Work Order ID 89019

Item Name: Crosstube Fwd

DART SERVICE INSTRUCTION

DART SERVICE INSTRUCTION

FIGURE 1 - GROUNDING STRAP INSTALLATION
(VIEW LOOKING FWD)

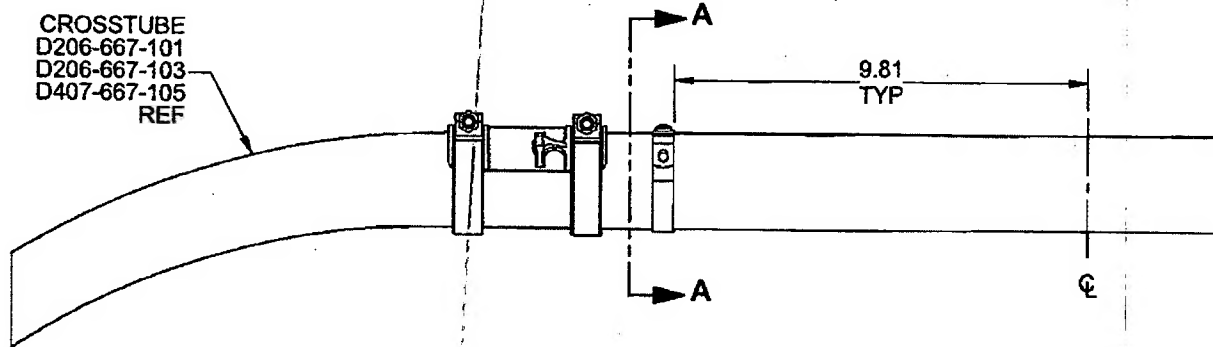
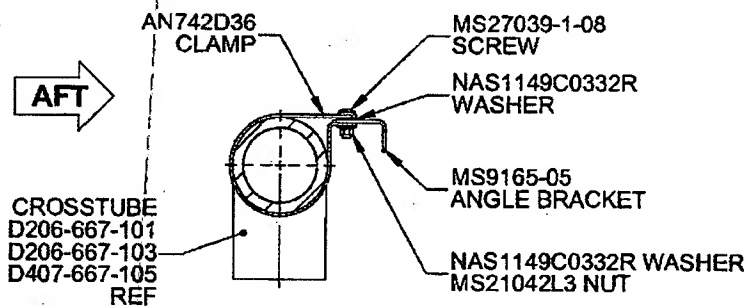
The purpose of this service instruction is to add the optional D206-667-017 Kit and provide guidelines to install extra clamps on D206-667-101/-103 or D407-667-105 forward crosstubes to allow fastening of OEM grounding straps.

- 1) If installed, follow Section 32.1 of ICA-D206-667 for removal of the forward crosstube from the helicopter.
- 2) Locate AN742D36 Clamp as shown in Figure 1 of this service instruction and mark location of clamp on the crosstube.

- 4) Install AN742D36 Clamp complete with MS9165-05 per Section A-A of Figure 1 of this service instruction.
- 5) Touch up paint as required per Item 5.3.3 of ICA-D206-667.
